Eastowne SUP Medical Office Building

August 16, 2018

Town Council Eastowne Concerns

Town Council Concerns and Responses Executive Summary

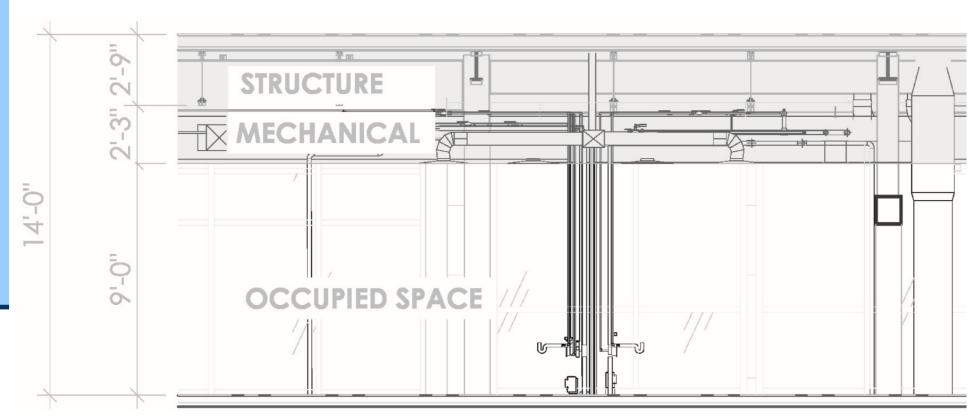
2. It appears that the building will be 105 feet high, equivalent, perhaps, to a nine-story building. This building is too tall for the area and becomes the precedent for all future buildings in the area.

Applicant Response: The proposed building is 6 stories (14' 0" typ x 6 + parapet) or 89'-4" with a ceiling height of 9 feet which provides additional clearance for specialty HVAC. Reducing floor to floor heights will lower the building height to under 90', which is modified from 95'. See following elevation and floor to floor section illustrating use of heights specified.

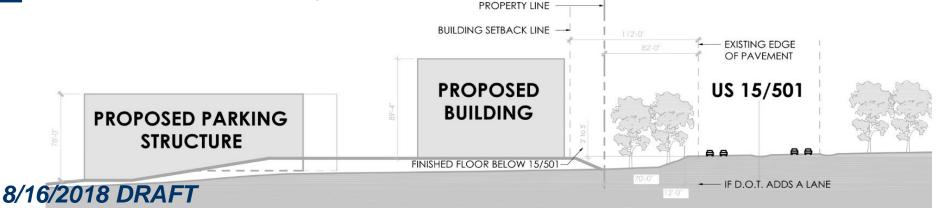
3. This sets the tone for the whole 15-501 corridor. Will there be requests for even higher buildings in this section of town? With Gateway & SECU Developments, the feel of coming into such tall buildings at this main entrance to Chapel Hill is important. / Being so large so close to the road, makes the building feel even bigger. Our interest is urban design but not at the expense of feeling like a canyon down 15-501

Applicant Response: Building is set back from 15-501 a distance of 112'. We are proposing to preserve a considerable amount of the buffer vegetation and even with future road widening along 15-501, there will still be 100' of separation. The required on-site 30' buffer is being maintained. Also, please note that the building height is less than the set back from the edge of payment.

This creates a commonly accepted 1 to 1 ratio.

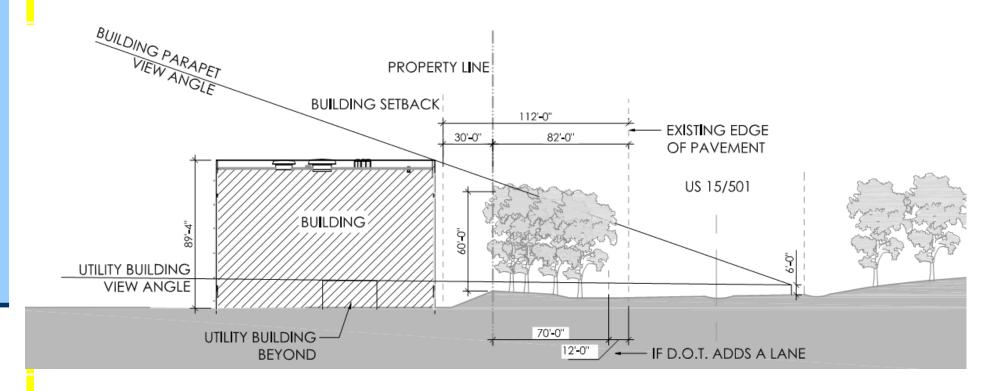
4. Is a basement level a strategy to reduce overall height?

Applicant Response: A basement is not practical for this project due to costs of rock excavation and foundation walls, an increase of required rock blasting, and access to daylight for patients.

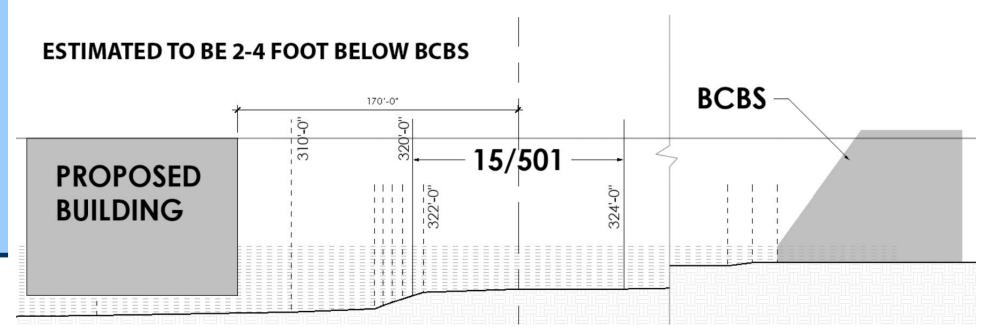
5. Where is the best place for the mechanicals of the building?

5. Illustrations cont'd. Below is a comparison between BCBS height relative to 15-501 as well as the proposed Eastowne MOB.

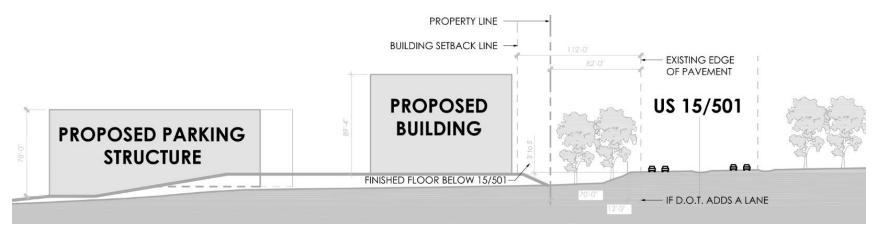
7. How tall will the building be from each corner to the ground?

Applicant Response: The topography around the building varies; therefore, we have shown multiple heights along 15-501 to try and clarify building height at FFE versus the topography created in the grading plans. Please see exhibit on the following slide.

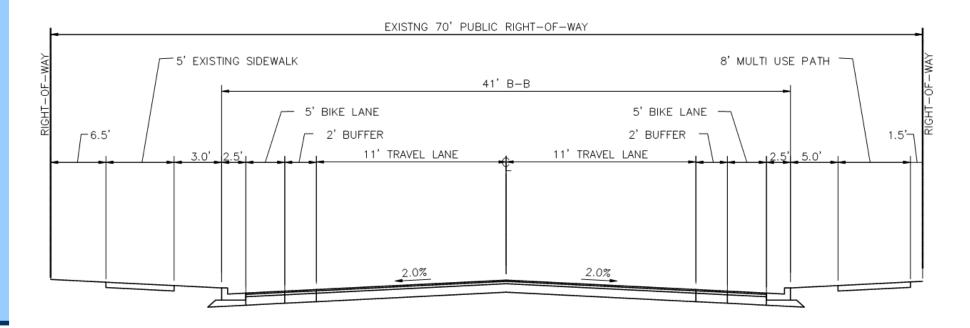
12. Need to make sure there is space left along Eastowne Road in case it has to be widened at some point in the future – turn lane width or additional lanes. Building placement should not preclude this –

Staff Response: Town staff identified a possible cross section based on the draft Town Design Manual. The cross-section would have two 11' travel lanes; one 10' turn lane at intersections; two 5' bike lanes with buffer; planting strip; and sidewalks. The placement of the building and the parking deck would be located outside of these right-of-way requirements. Please see following drawing for clarity.

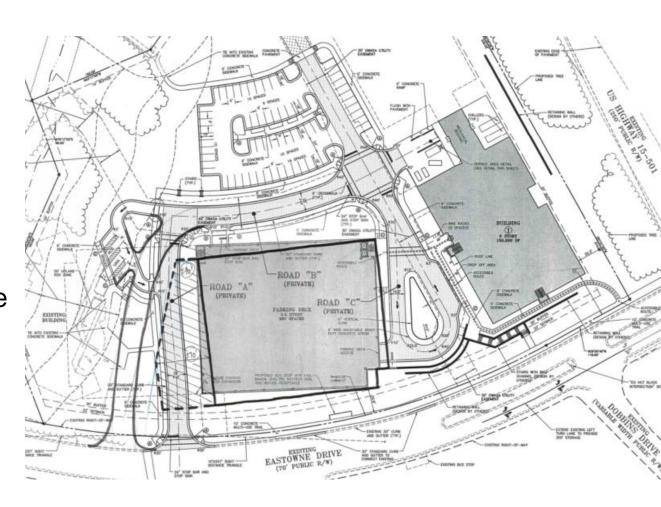
13. Consider traffic circle in front of parking deck – there is already a great number of cars coming down Eastowne Rd from other medical & apartment complex such that making a left turn out of the parking deck onto Eastowne Rd is complicated – maybe not for first building but for full build out – at least plan for this to help with traffic flow. Adding this number of cars into one entrance is huge for this section of road – traffic circle or something to keep movement and prevent stacking in either direction

Applicant Response: We considered a traffic circle at this location and determined it created several impacts to the project and adjacent landowners, including the loss of full access movement for Pinegate Apartments, and impact on existing environmental features. A traffic circle may be viable with the future Pinegate redevelopment but should be evaluated with overall Master Plan.

Staff Response: We believe placement of a traffic circle at the parking deck entrance may cause conflict with the Pinegate Apartments driveway. It is recommended as part of the Master Plan traffic impact scope of work that a traffic circle be considered at the intersection of Eastowne Drive and Old Sterling Drive.

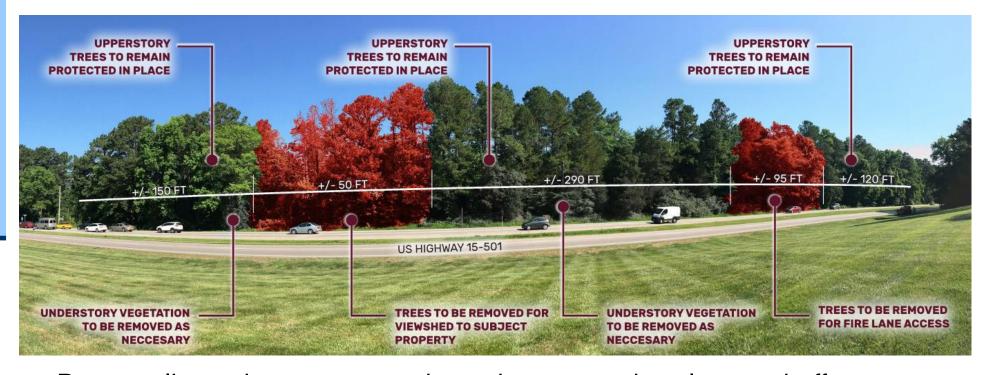
15. Is there a way to connect bike path/multi modal pathway through complex and adjoin to fire road or just not against roadway? Want mobility but not at the expense of tree buffer and possible widening of 15-501. Is multi use of fire path a good option?

Applicant Response: We have removed the greenway trail along 15-501 and are open to having a pedestrian connection go thru this site and connect to future greenway as part of the masterplan.

- ✓ Clean up buffer of 15-501 ROW & landscaping enhancements.
- ✓ Removed Greenway
- ✓ Provided a view corridor.
- √ 68% of wooded frontage is being retained.

Staff Response: The developer is considering connection of multi-use paths through the entire Eastowne property. A stipulation has been included in Revised Resolution A. Bicycle and pedestrian facilities are recommended along Eastowne Drive providing connections to Old Sterling Drive and Dobbins Drive.

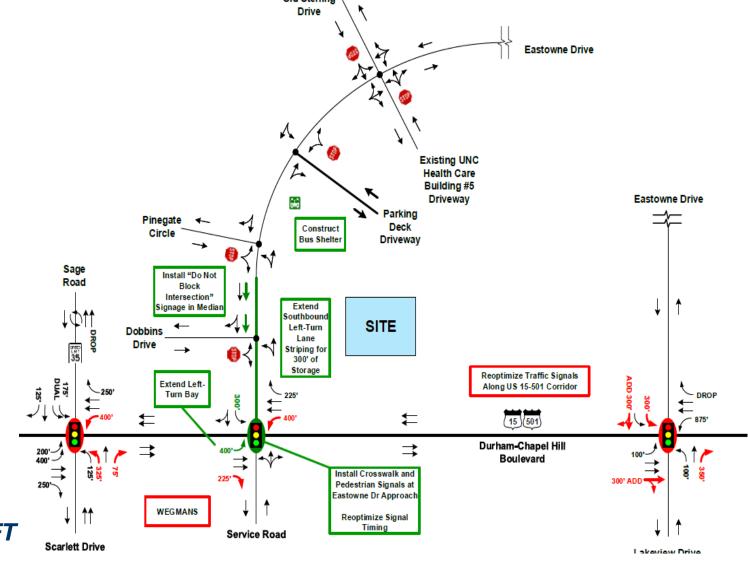
20. What specific improvements are required?

Staff Response: Improvements required are shown below:

- Extend northbound left-turn lane on 15-501 to 400' for added vehicle queuing;
- Extend Eastowne Drive left-turn lane onto 15-501 to 300' for added vehicle queuing;
- Install crosswalk and pedestrian signals at Eastowne Drive for improved passage across 15-501 and a connection to the future Wegmans;
- Construct a new bus shelter along Eastowne Drive adjacent to proposed development;
- Install "Do Not Block Intersection" signage in median along Eastowne Drive.

- Reoptimization of traffic signal timing on US 15-501;
- Add a second 300' left lane from Eastowne Drive to US 15-501.

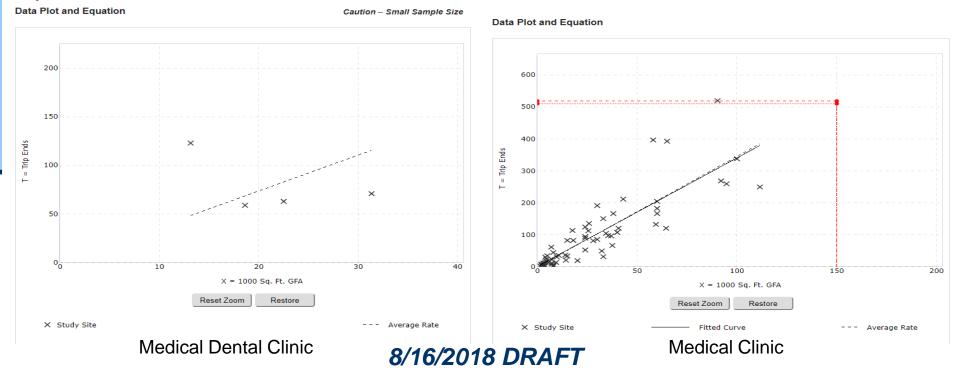
25. How did the consultant incorporate the ITE Manual when making trip generation calculations for the Eastowne project?

Staff Response: The consultant reviewed the available ITE Manual data on land uses related to the proposed UNC Health Care facility (720 – Medical-Dental Office Building, 630 - Medical Clinic), as well as the existing facilities. There are two trip generation options for these land uses – number of employees and square footage. Based on the ITE Manual data available and compared to the applicant-supplied information, the consultant determined that the number of employees was the most appropriate variable to use.

A second consideration is the particular land use type (or "code") from the manual that best approximates the land use in the proposed project. In this case, the consultant averaged the trip generation results of the two land use codes listed above to best approximate the land use in the Eastowne project. For the existing site, the Applicant shared that the existing facilities function as general office buildings (not clinics), so the ITE Manual code for General Office Buildings (710) was utilized to estimate existing trip generation of the fully utilized existing facilities.

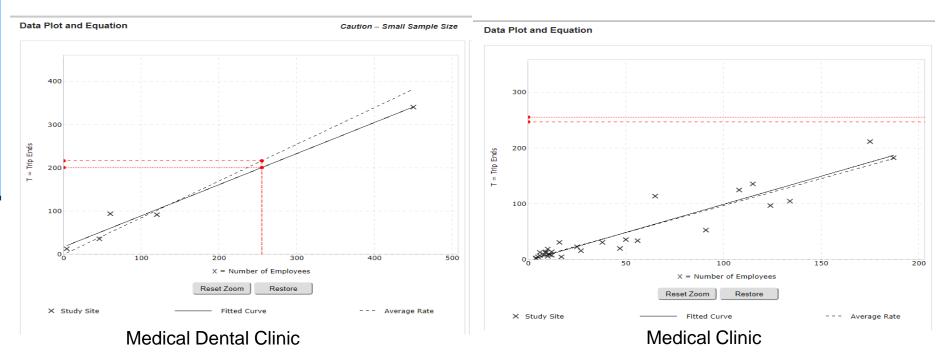
25. Cont'd: How are trips calculated? (Number of Employees)

Staff Response: Using the maximum number of staff as a trip generating variable for the Medical Clinic and Medical-Dental Office Building ITE Land Use Codes produces comparable results that were averaged to produce and estimate of daily and peak hour trip generation for the facility at full build-out
